No.	Date	Description
1	2025-09-19	Add No. 1
2	2025-09-30	Add No. 2

**WCFPD Station 3**  
**Wright City Fire Protection District**  
9 Highway WW  
Wright City, MO 63390

**ROOF PLAN GENERAL NOTES**

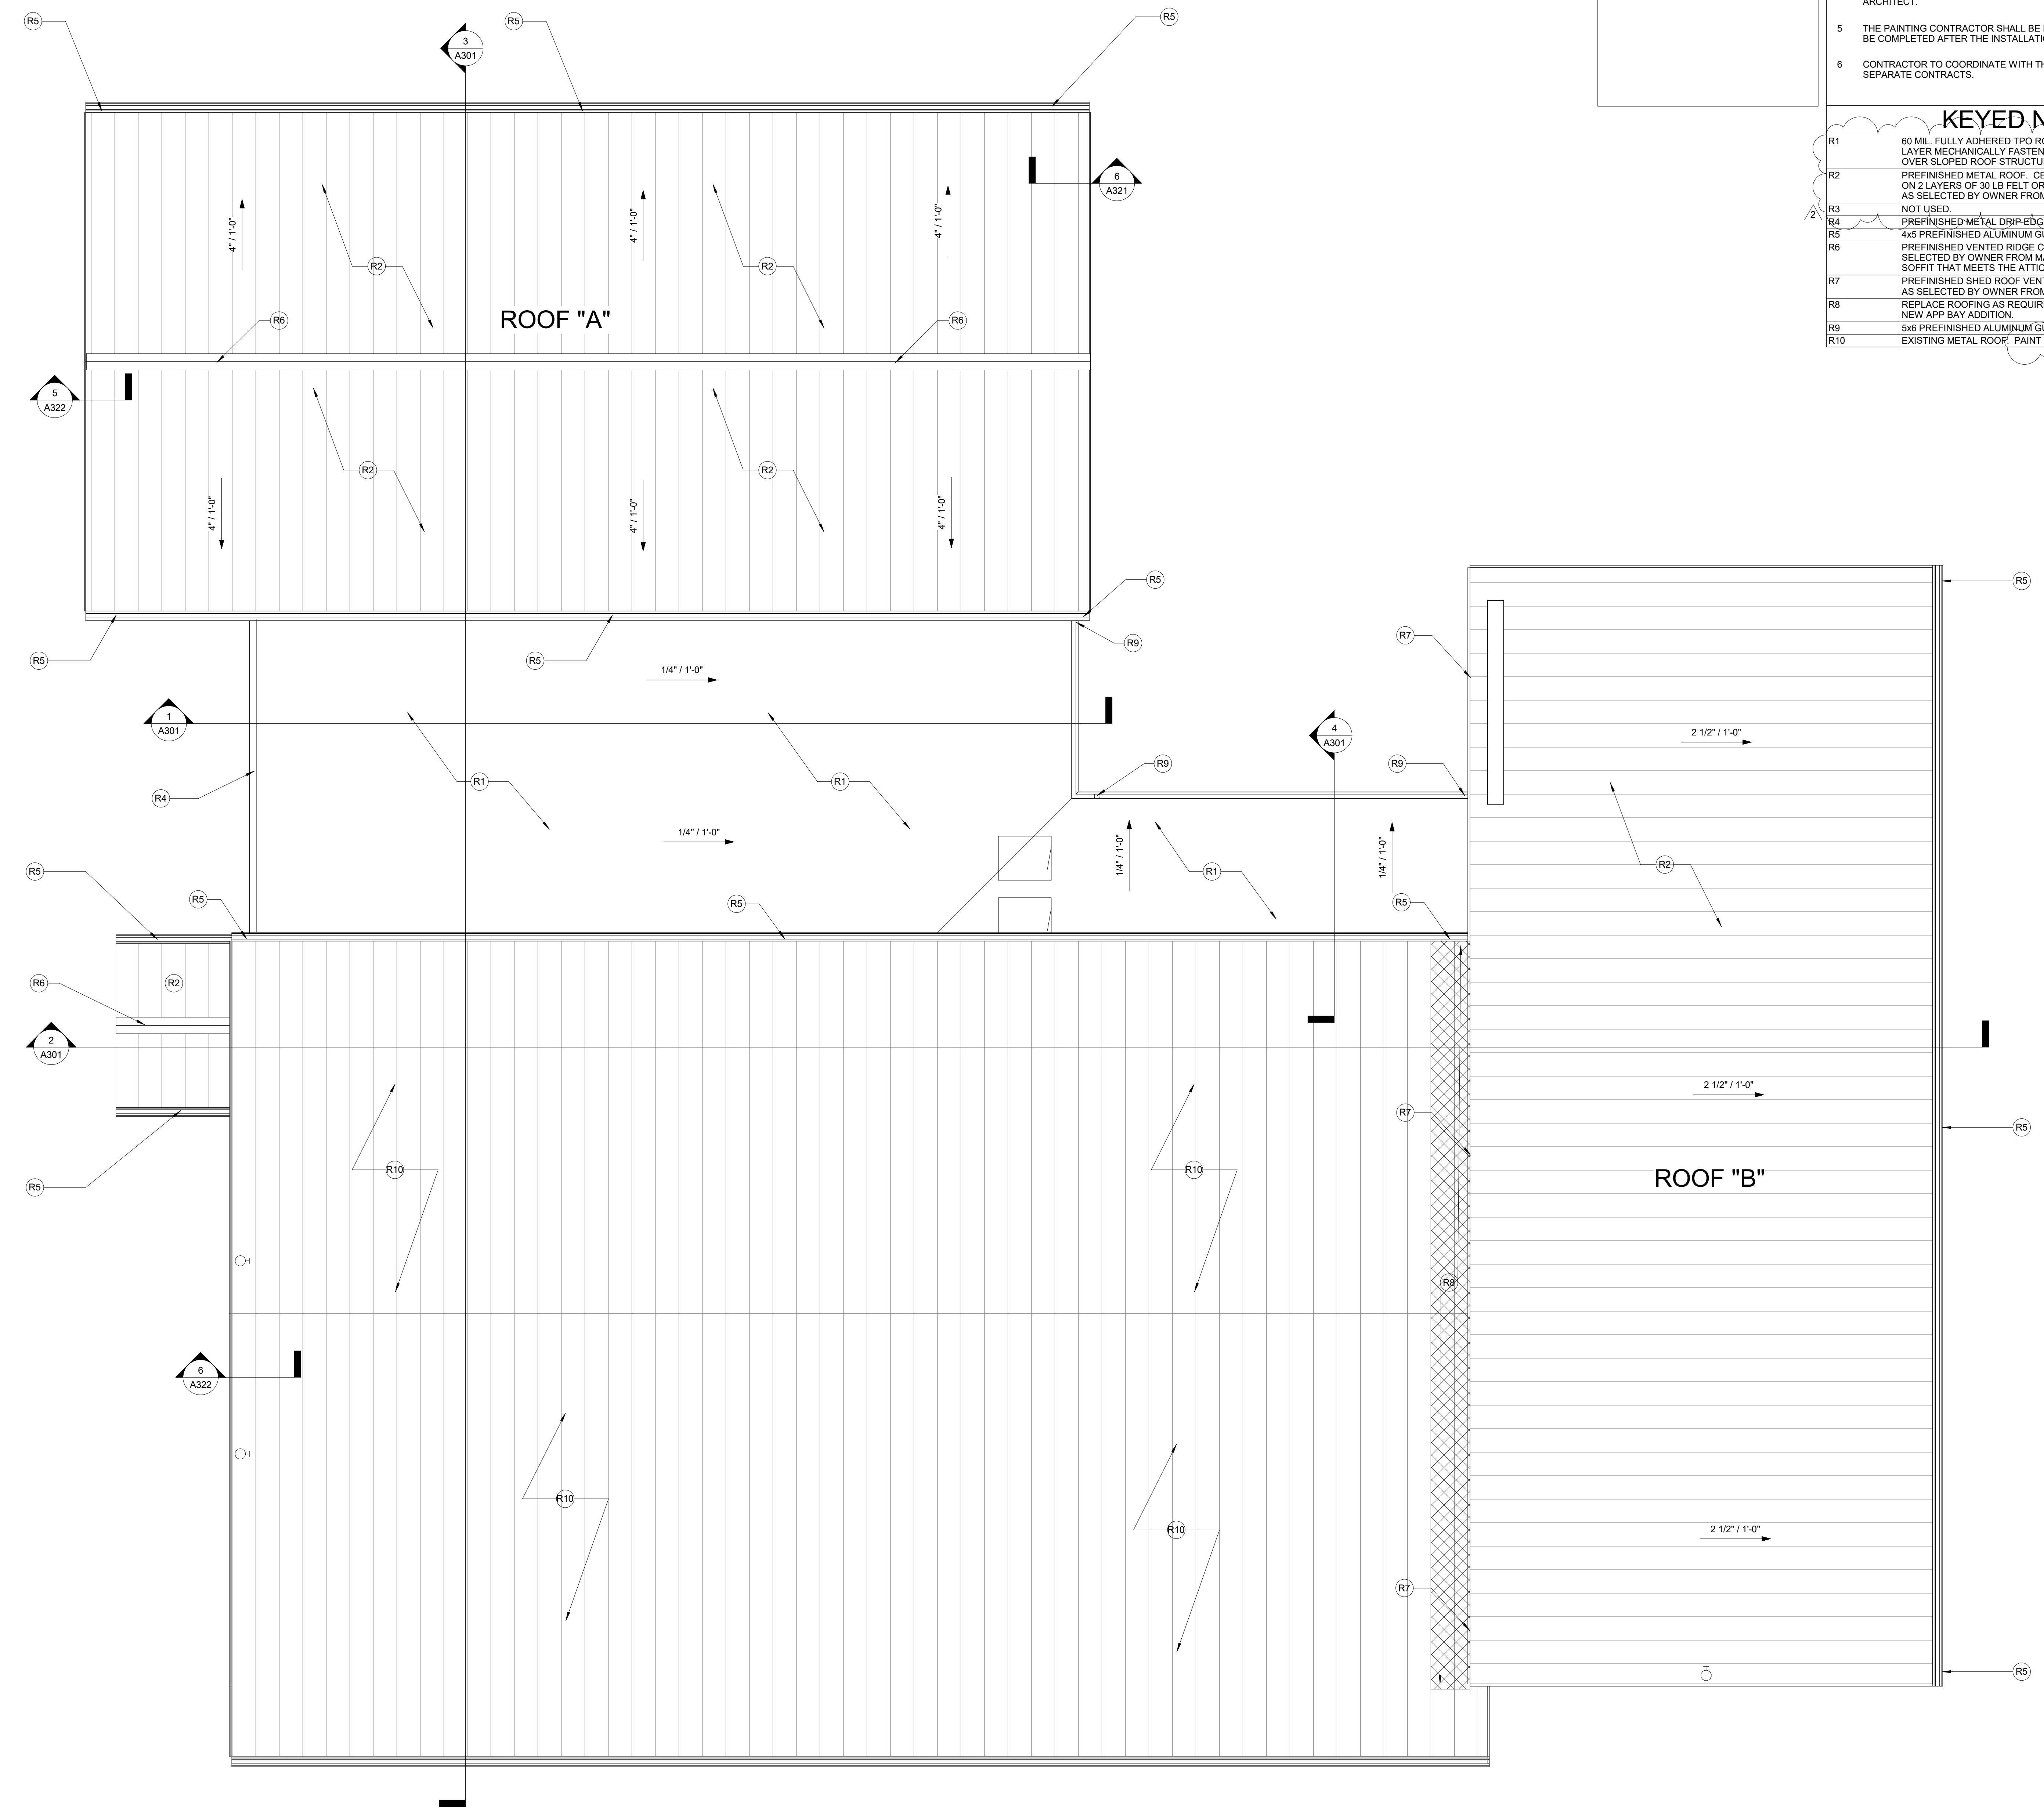
- 18) Sheet A141 – ROOF PLAN
- a. REVISED Keyed Notes R1, R2 and R10 and eliminated Keyed Note R3.
- 19) Sheet A201 – EXTERIOR ELEVATIONS
- a. REVISE Keyed Note E1.

**2 NORTH ELEVATION**  
A201  
1/4" = 1'-0"

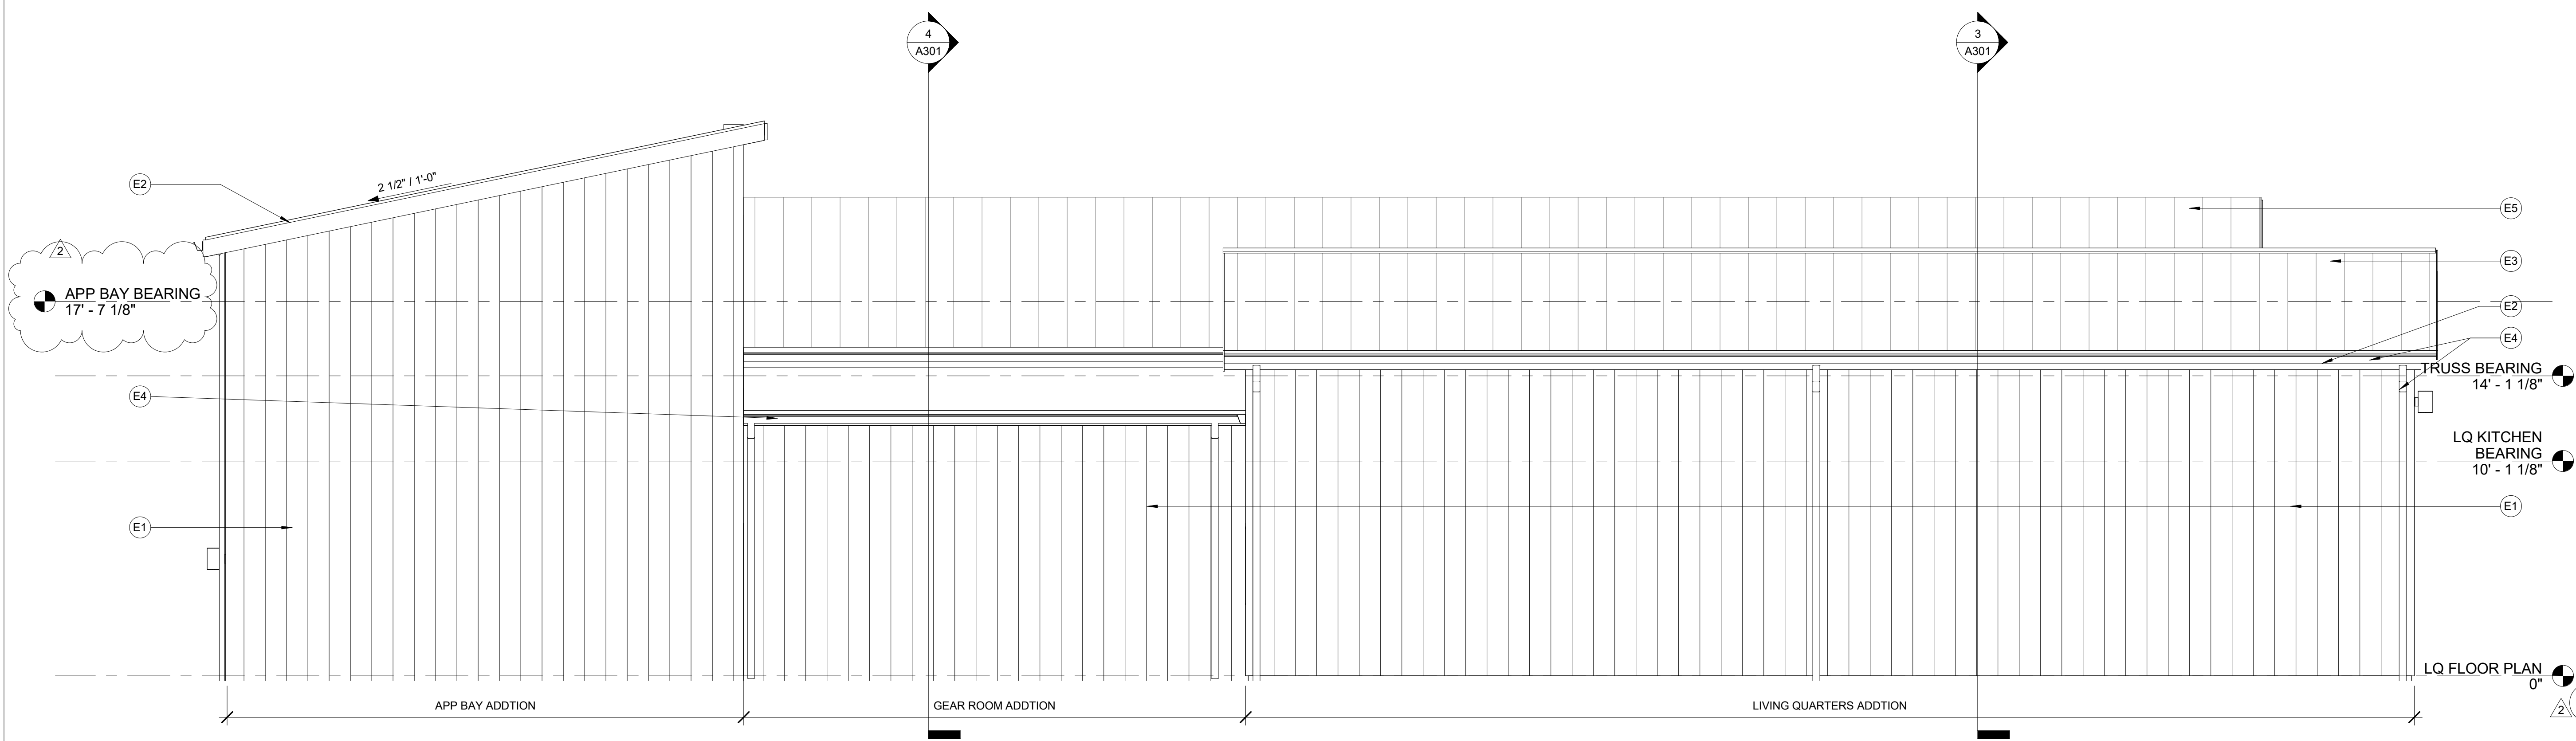
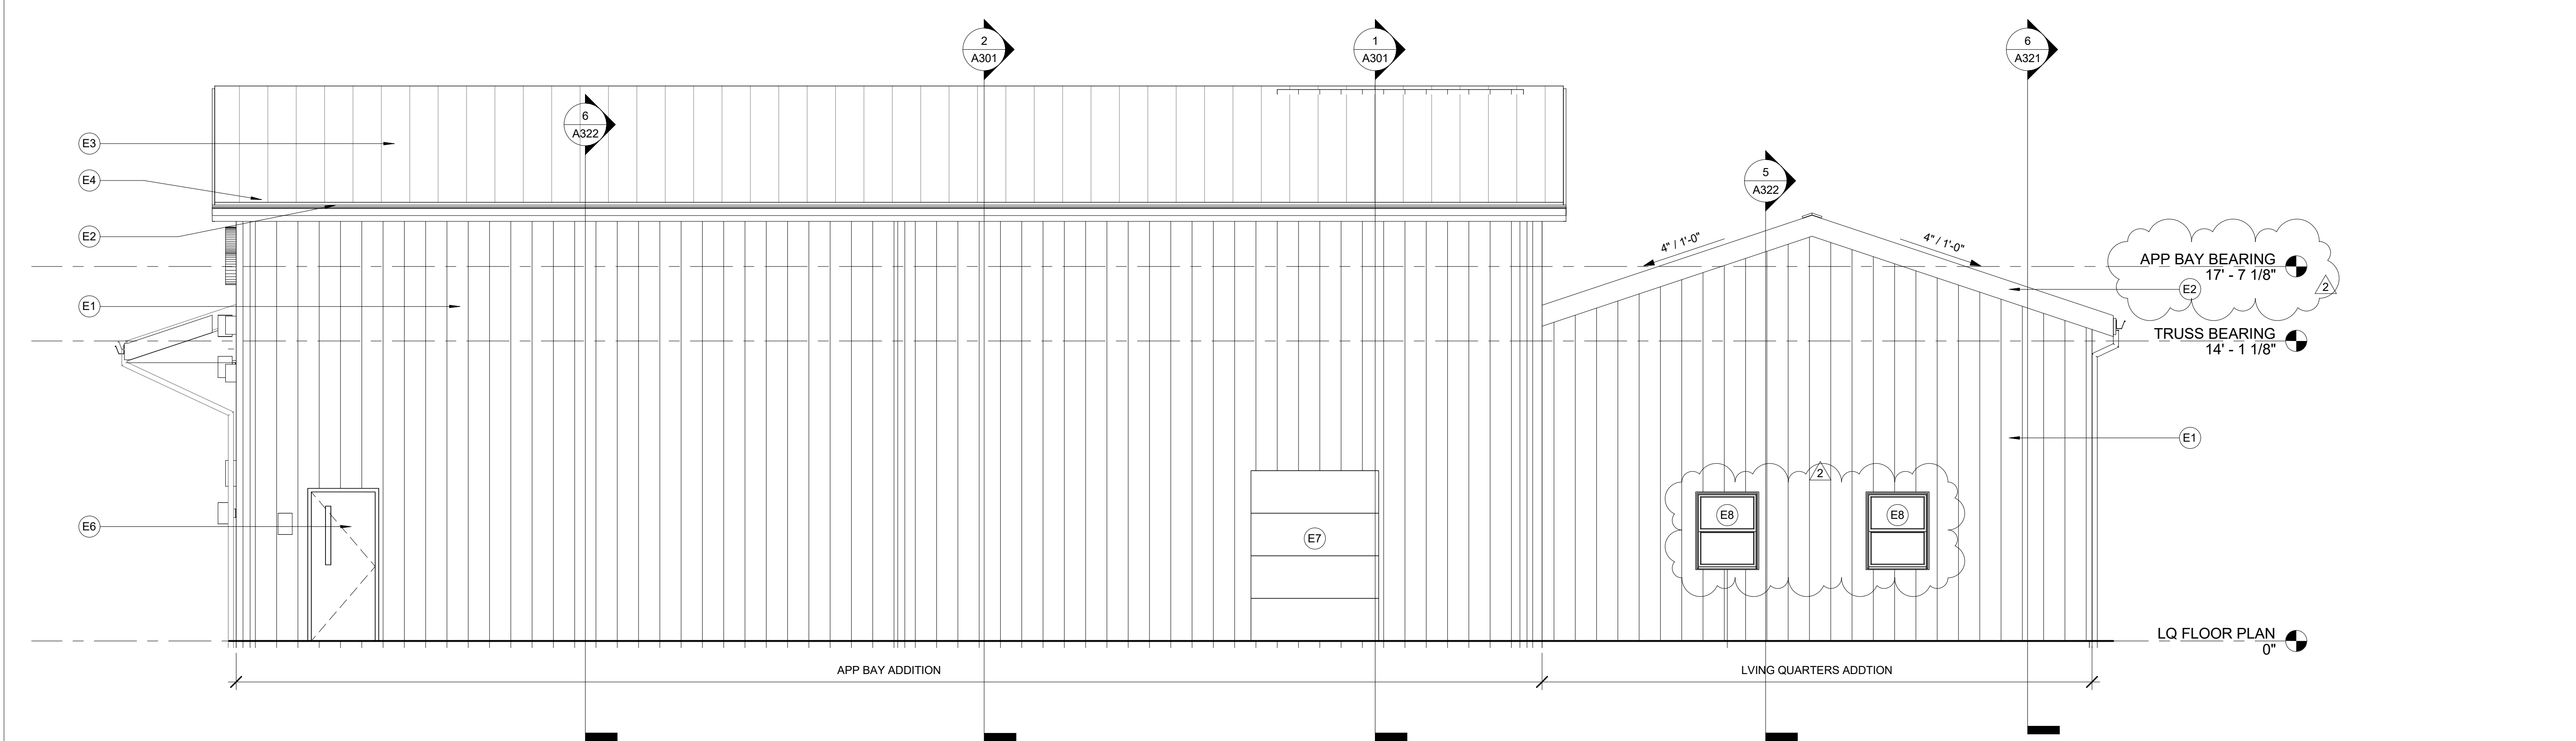
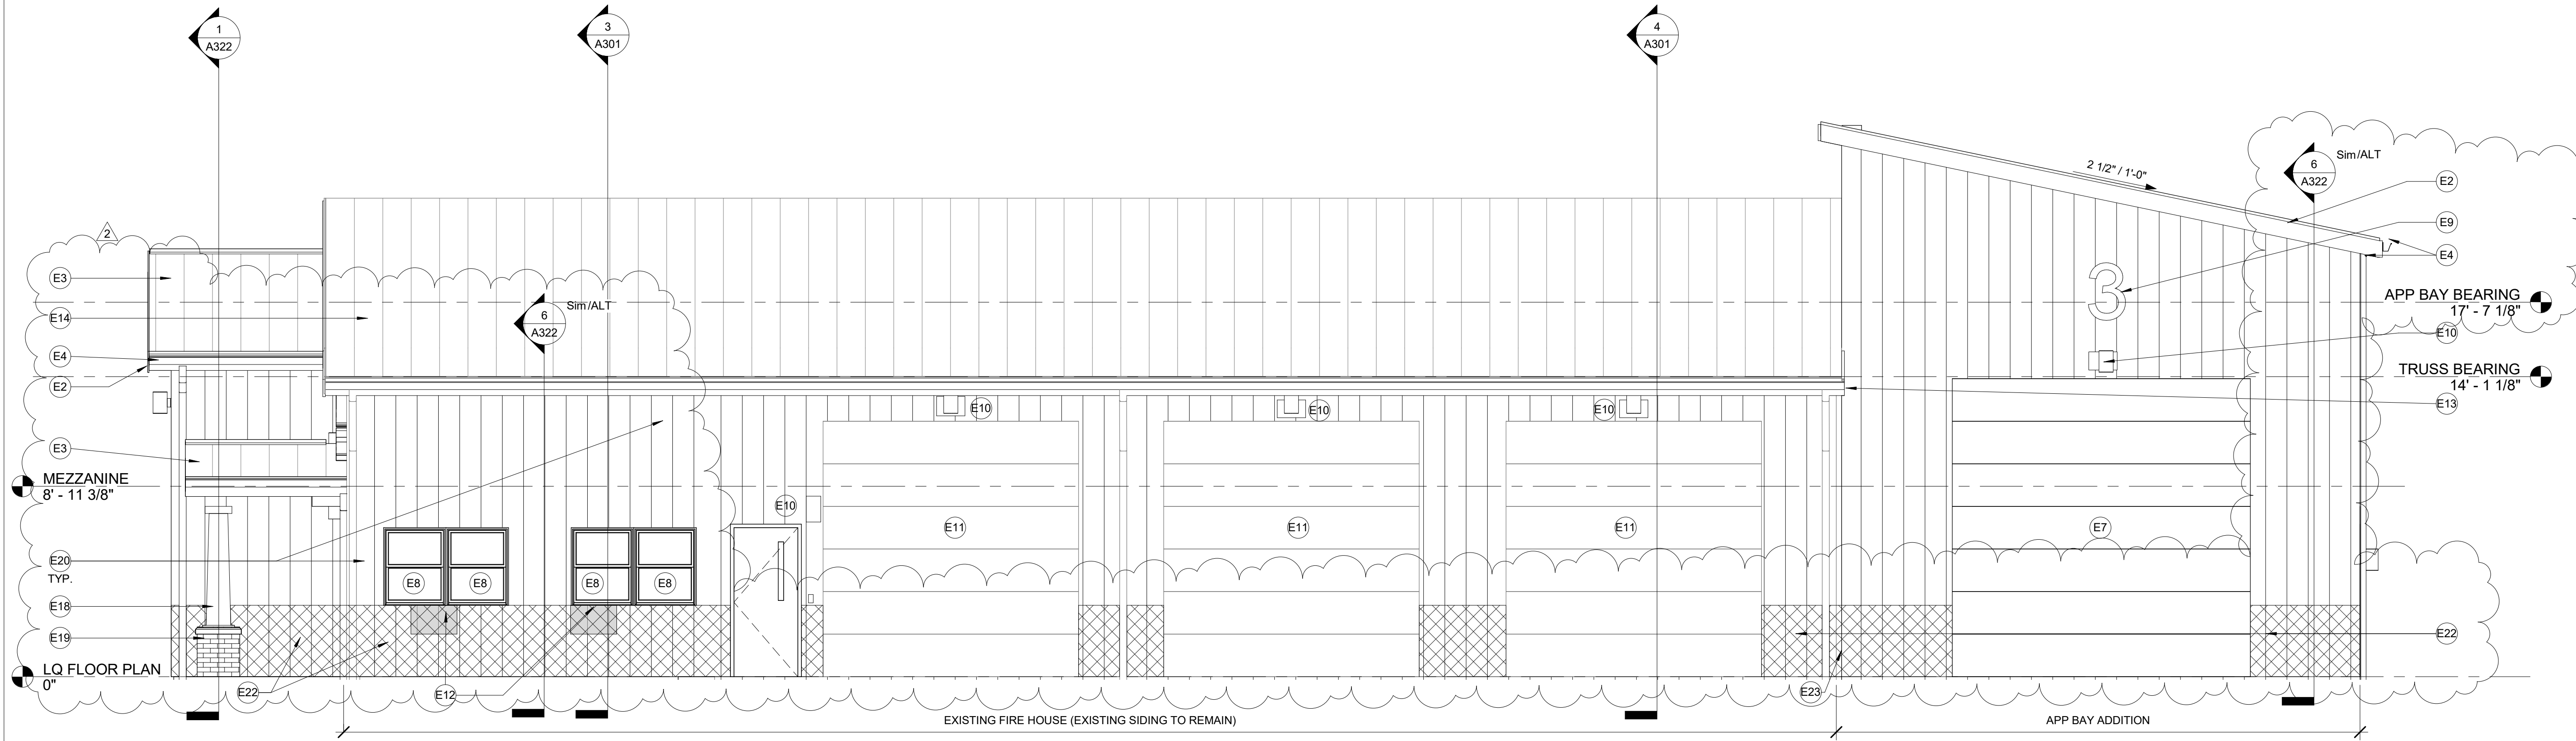
- b. ADD notations to the South elevation.
  - c. ADD Keyed Notes E21, E22 and E23.
  - d. REVISE the App Bay Bearing Height to 17' – 7 1/8" to match structural.

- e. REVISE the windows to be taller.
  - f. ADD hatch to the South elevation to show where the alternate for brick veneer or thin brick is located. Refer to the floor plan and wall sections 5/A322 and 6/A322.

- g. ADD and expansion joint between the existing and new buildings (Keyed Note E23).
- 20) Sheet A202 – EXTERIOR ELEVATIONS
- a. REVISE Keyed Note E1.
